REMARKS

Amendments to the Drawings

Amendments to the Drawings

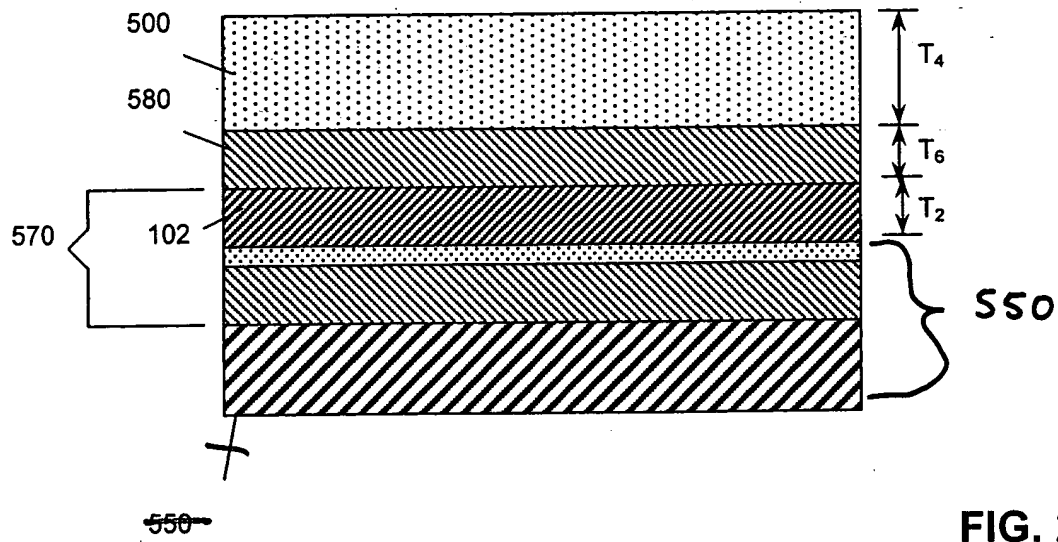
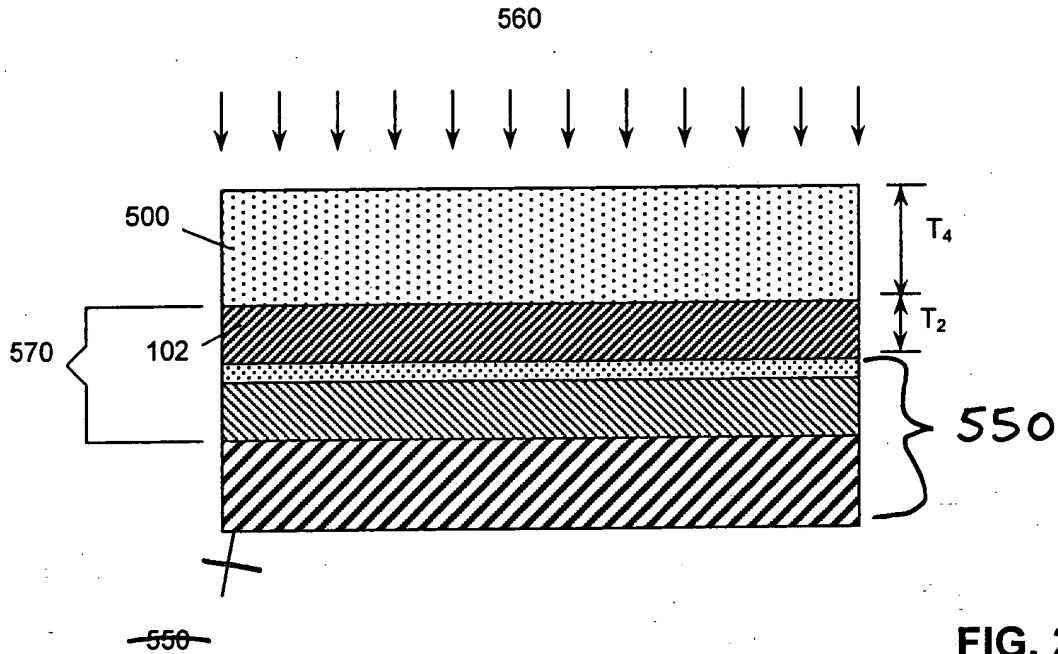
The attached replacement sheets of drawings include changes to FIGS. 2A-2B and FIGS. 3A-3B. These sheets, which include FIGS. 2A-2B and 3A-3B, replace the original sheets including FIGS. 2A-2B and 3A-3B. FIGS. 2A and 2B have been amended to more particularly point out the element to which the numeral 550 refers. FIGS. 3A and 3B have been amended to more particularly point out the element to which the numeral 650 refers.
